Sunlight House
L3 Meeting Room Glazing Strategy
Revised proposal from the 6th of November 2024

Previously Submitted Proposal Level 3

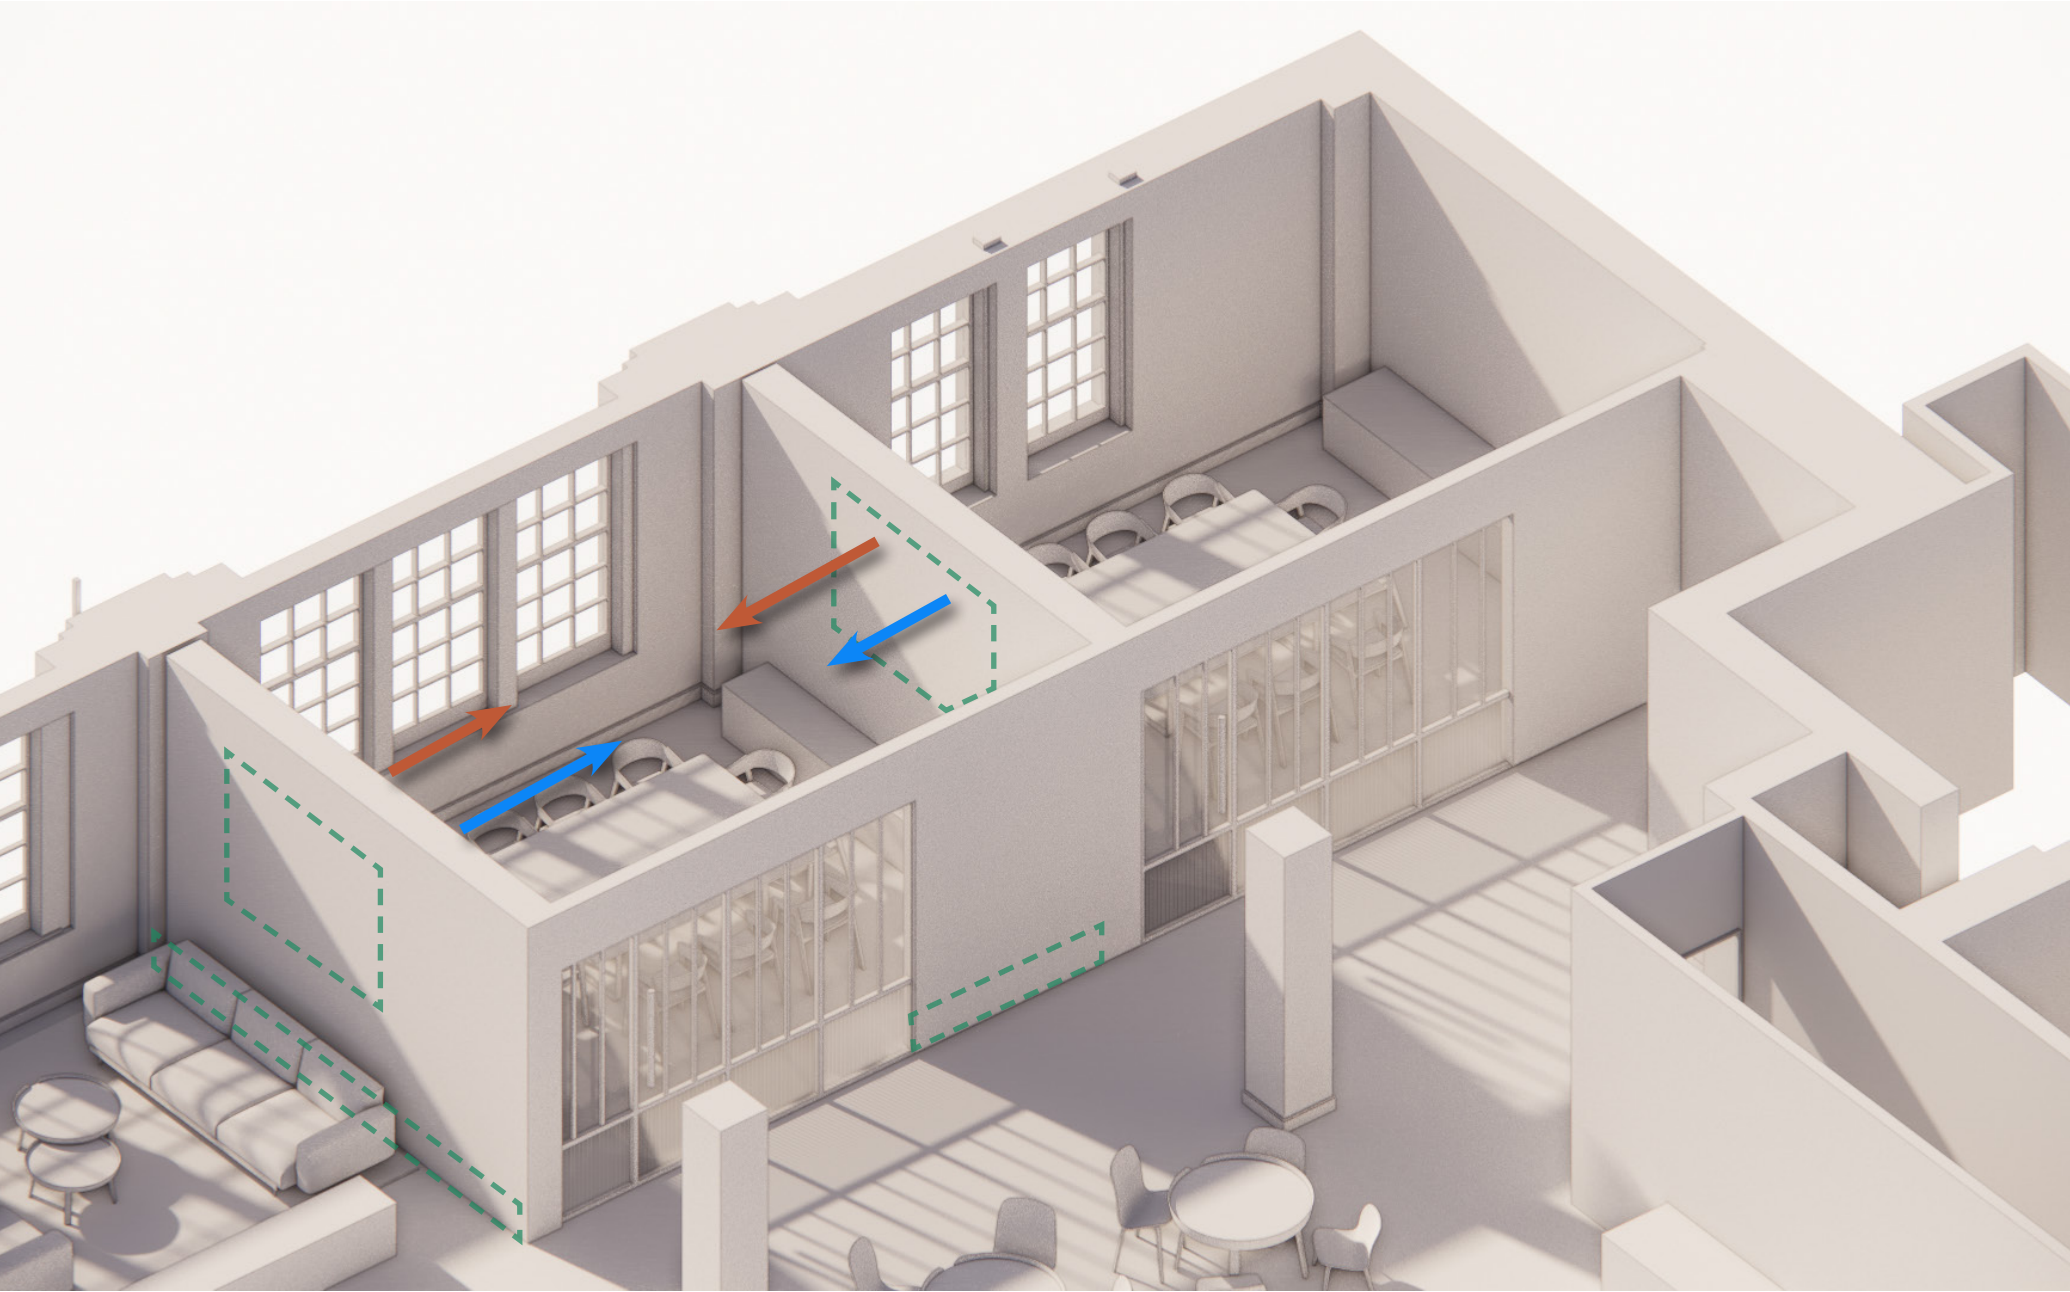
The proposal for the meeting room was to remove the the glazing on the side walls of the meeting rooms and replace it with a plasterboard partition. This approach will be standardised across all meeting rooms on this floor. This will improve the overall use of space for the following reasons:

- Increased visual and audio privacy for the meeting room. The improved acoustic performance of plasterboard over glazing will reduce reverberations and external noise transfer, as glazing will no longer back onto workspace areas.
- More flexibility in mounting AV screens/ writable wall due to more solid partition walls. This will avoid needing to fix equipment into the existing historic wall and will be a more efficient use of space.
- Small power can be installed as required throughout plasterboard walls to avoid the need for fixings into the historic wall.

Proposal following MCC comments on the 24/10 - rejected

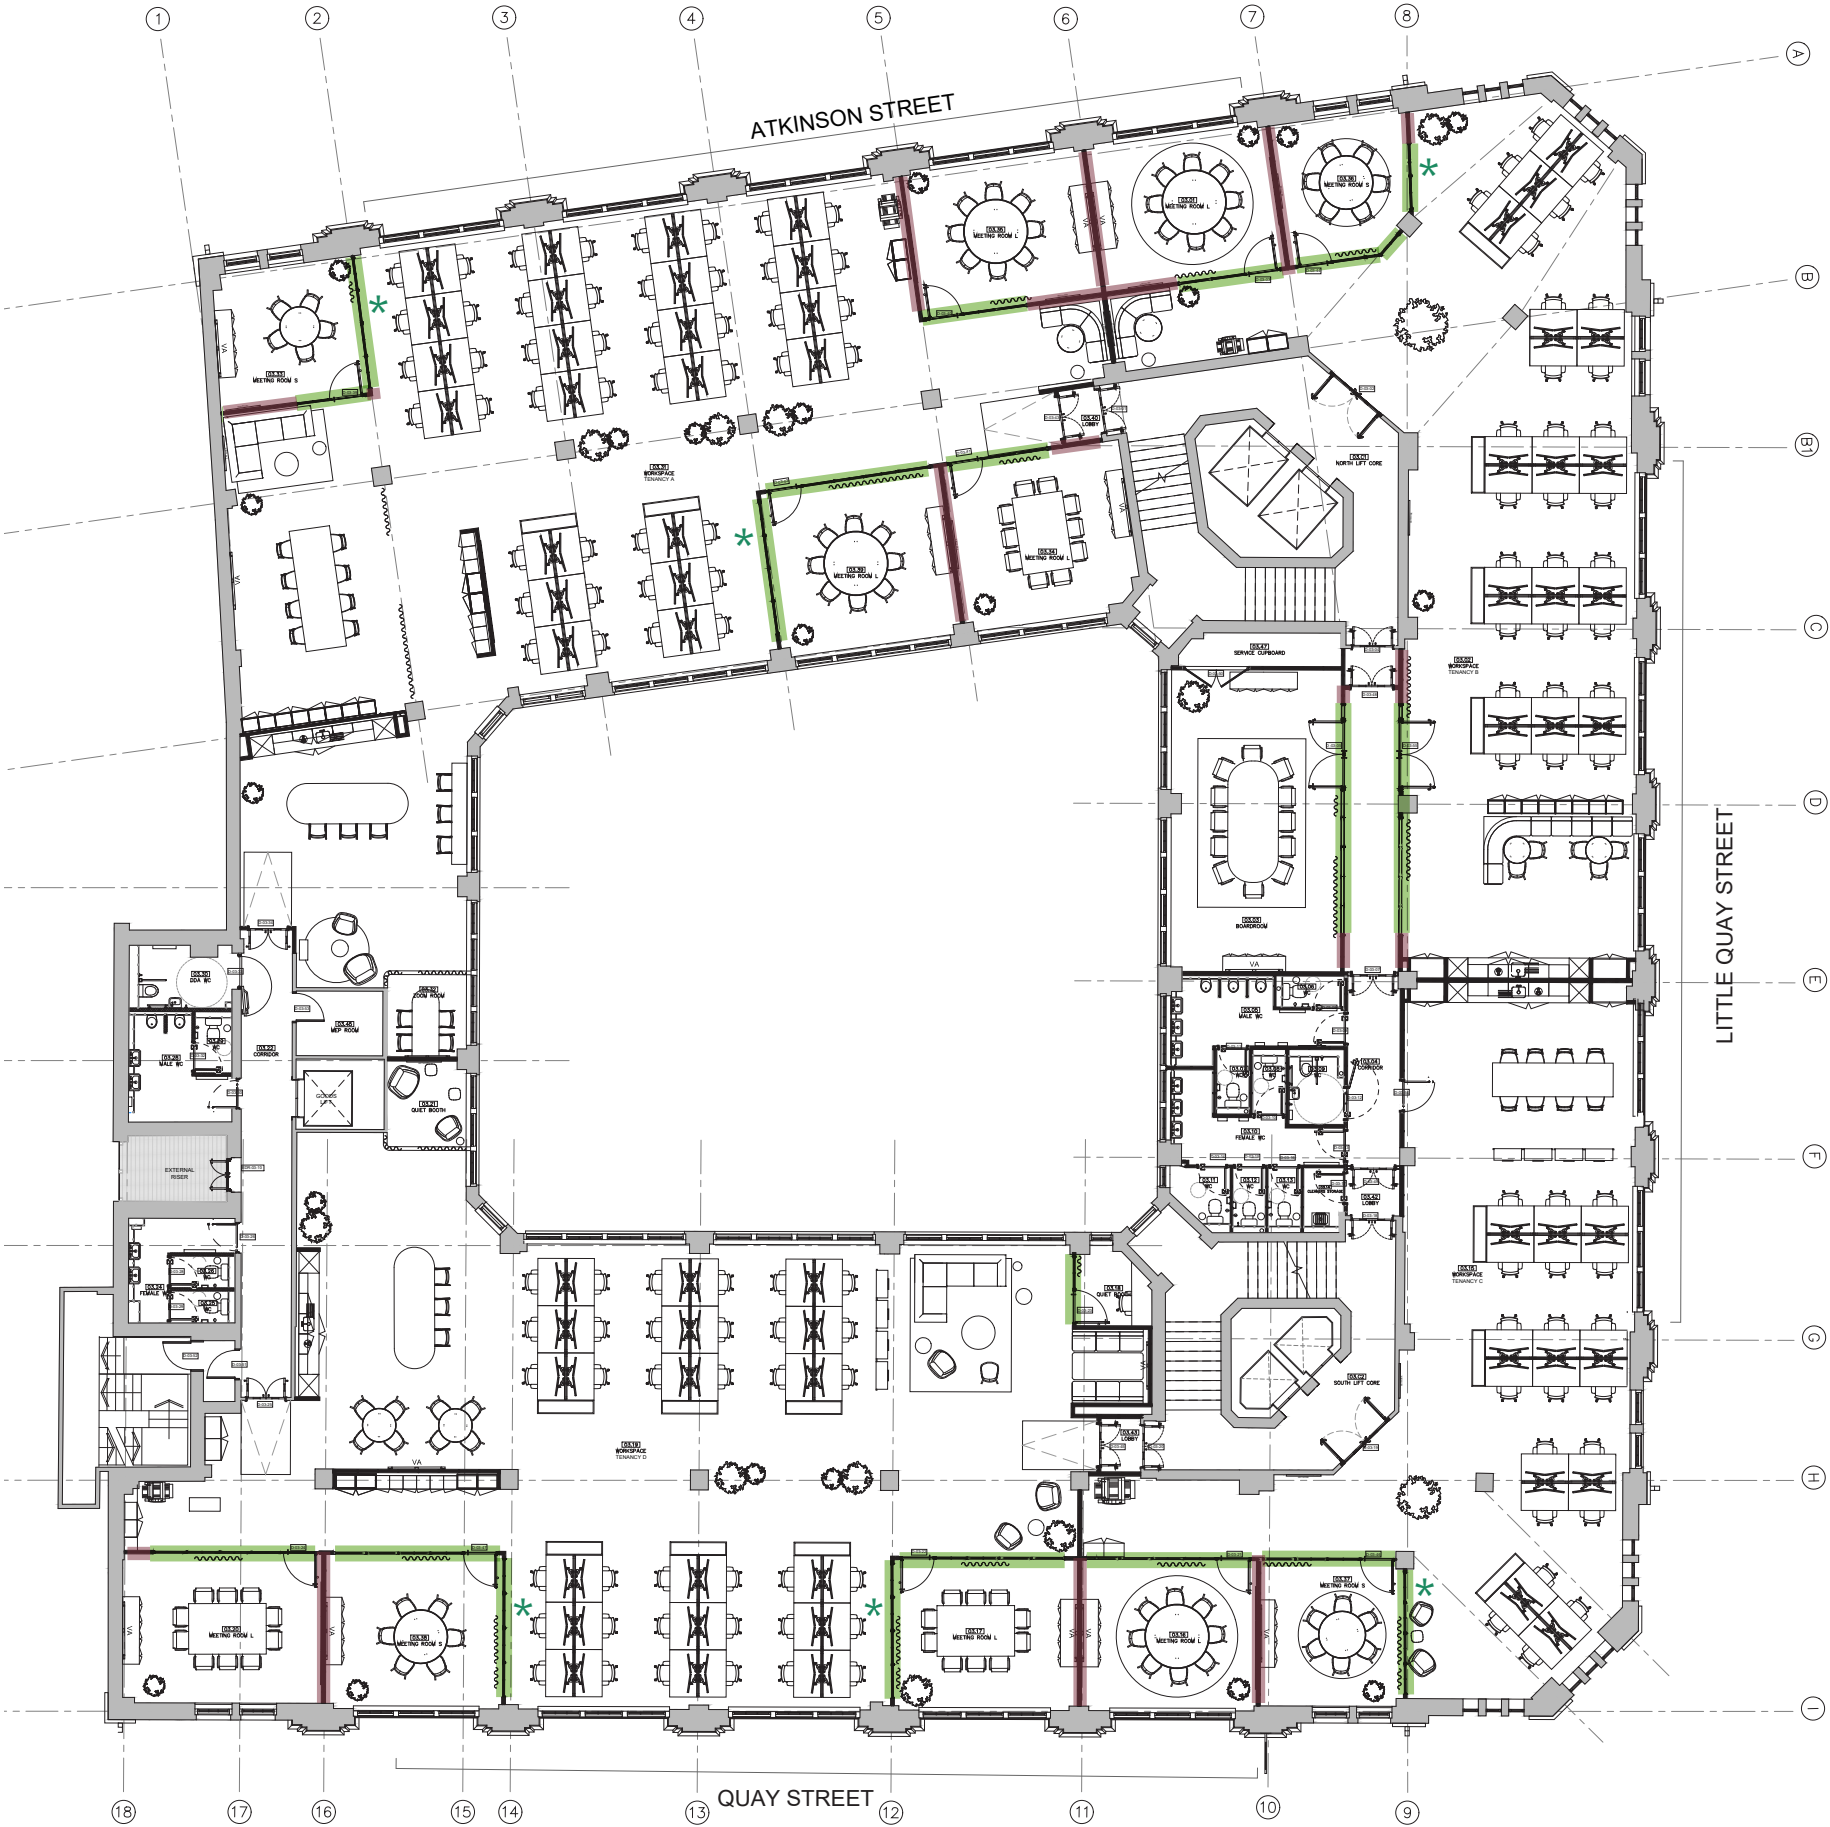
Following feedback from the meeting on the 24th and 25th October, the glazing on the front side of the meeting rooms will increase as shown.

Full front face of the meeting rooms will be glazed with additional smaller side panels for increased visibility.

Glazed screens facing the office floor desking or seating will be covered with opaque film cover.

Revised New Proposal following MCC comments on the 6/11

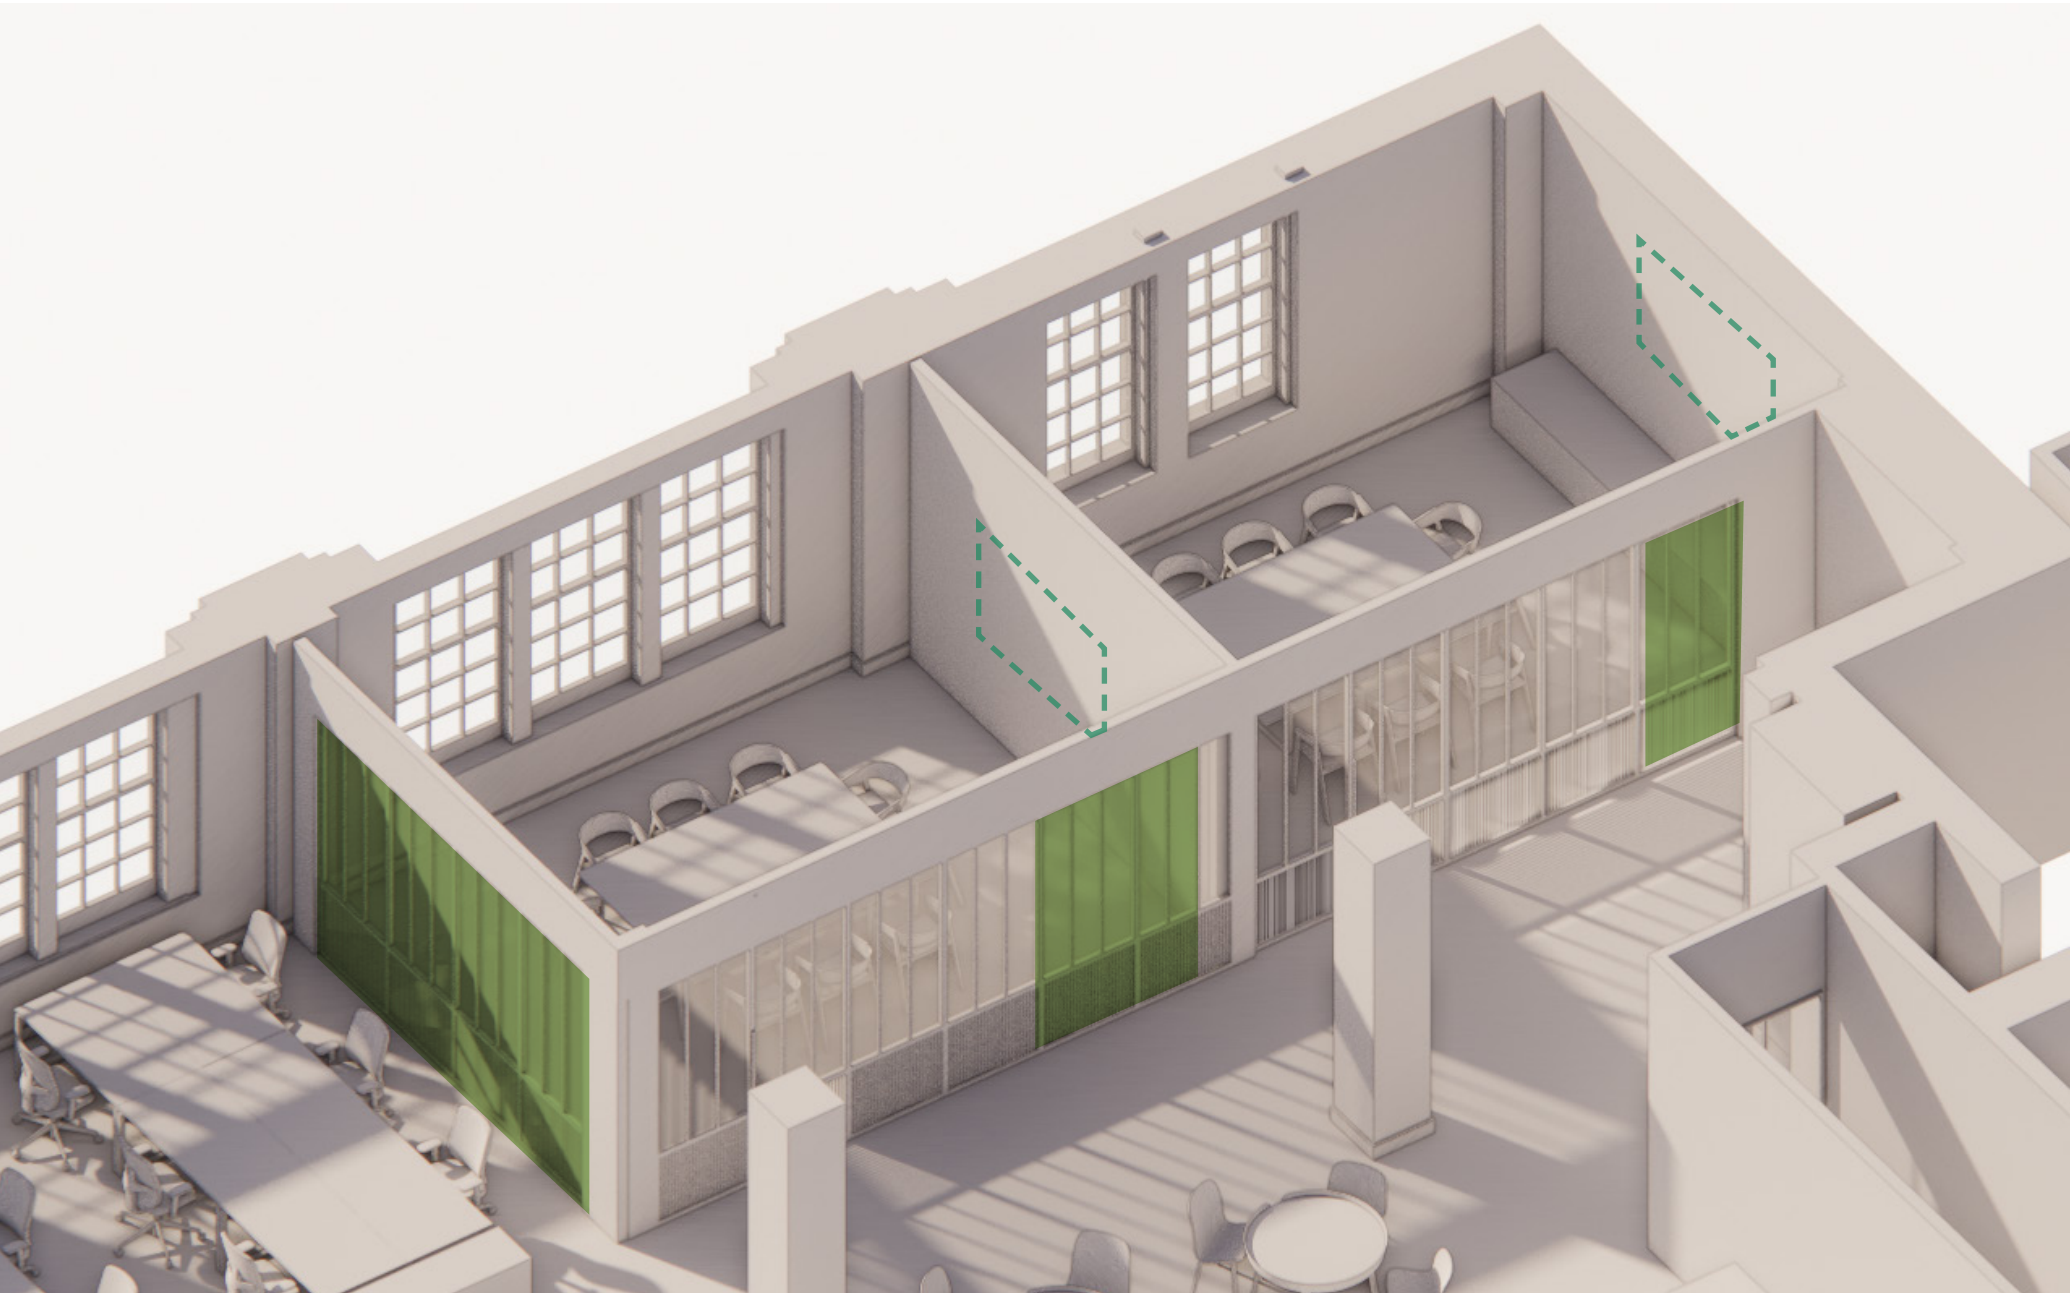
Following feedback from the meeting on the 6th of Novemeber, the glazing for the meeting rooms on the front side of the meeting rooms will increase as shown. Glazing will continue on the side walls of the meeting rooms facing the open office.

Glazed screens facing the office floor desking or seating will be covered with opaque film cover. There will also be a curtains within meeting rooms for privacy.

The revised proposal to increase the glazing on the front and side of the meeting rooms. In this approach the additional glazed wall is proposed to increase the overall visibility of the office floor, while keeping at least one plasterboard partition for the services and AV provision within the meeting rooms.

Typical glazed panels

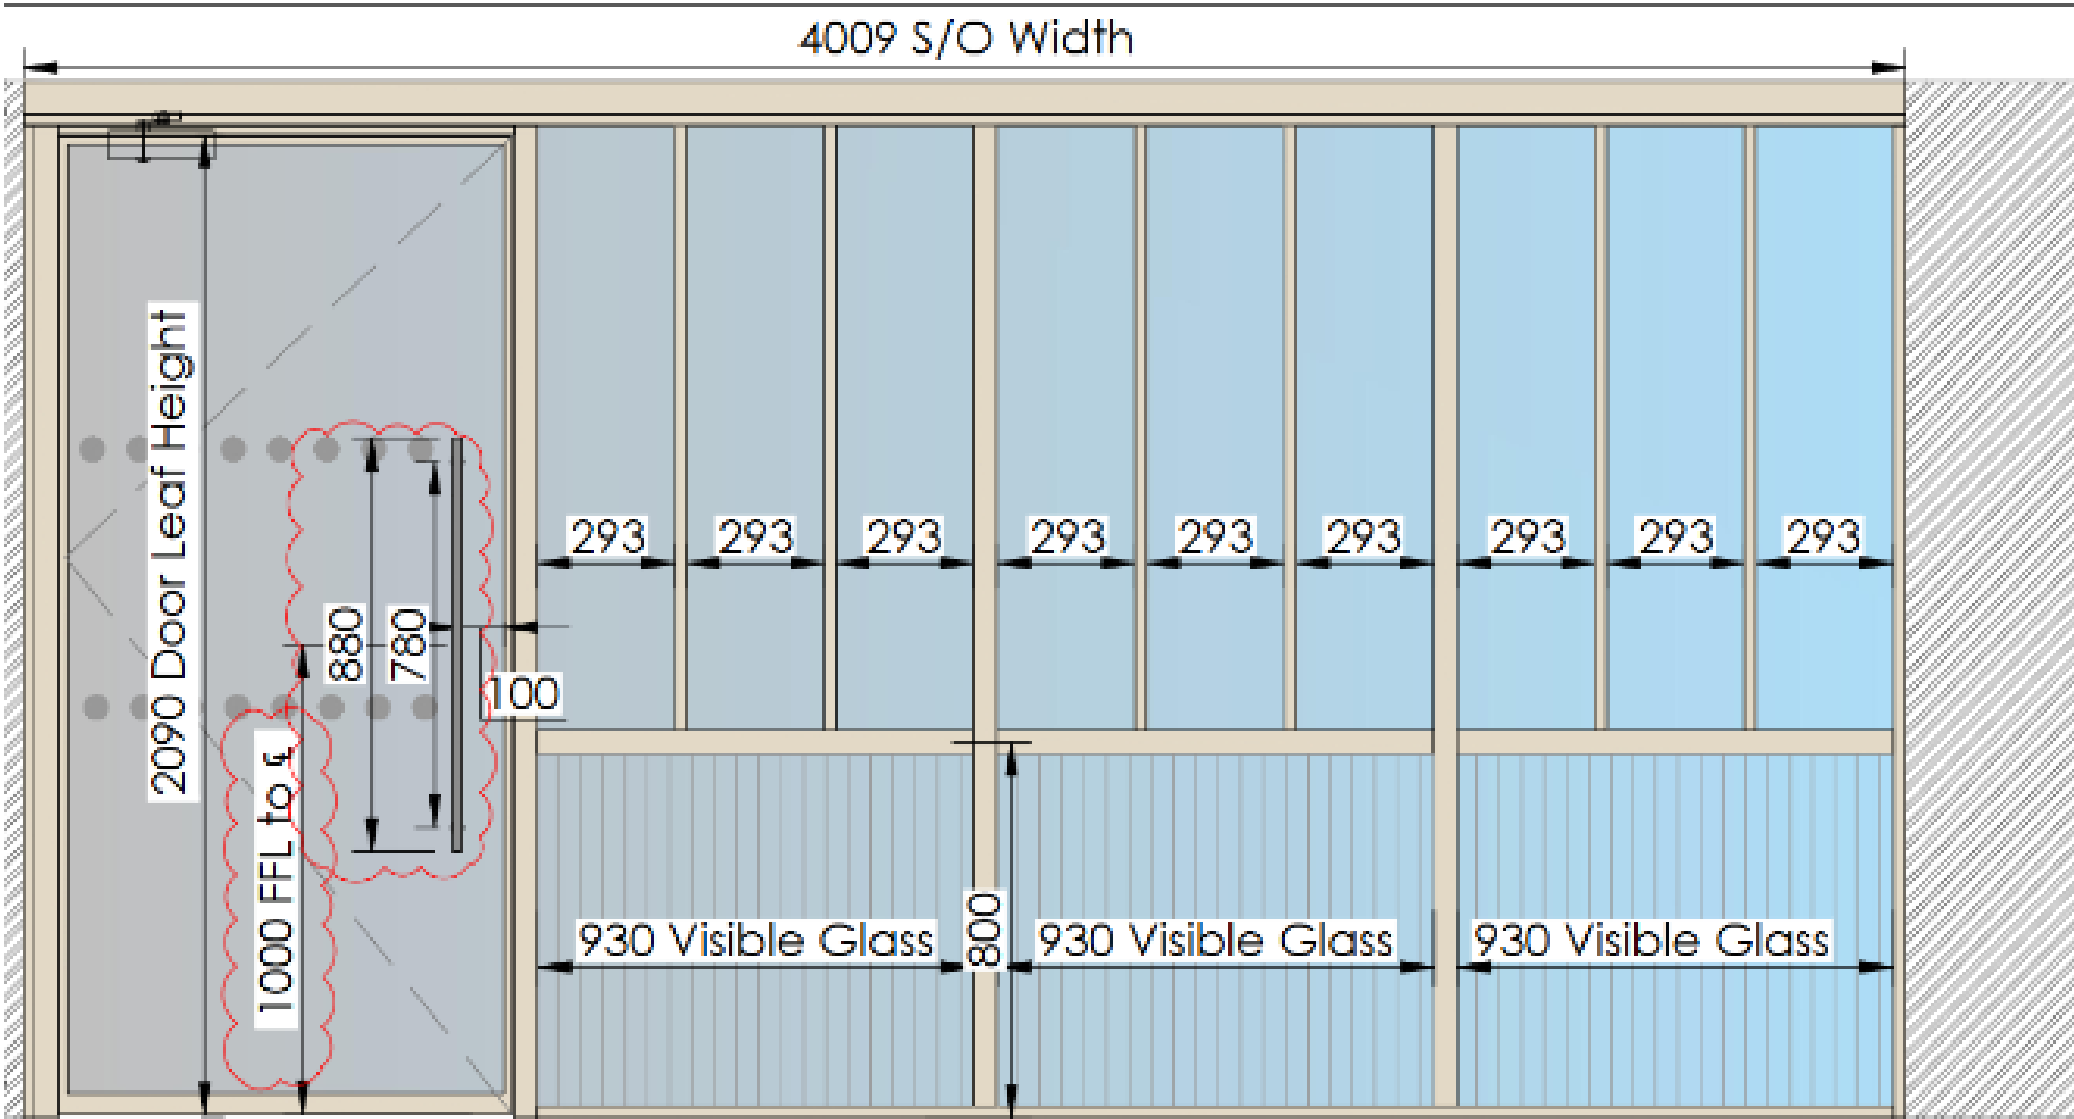
Typical fully glazed door with side panles.

Side panels will have top divided part with bottom section to be fluted glazing. Framing of the partitions are in a neutral beige colour metal frame - RAL 1013
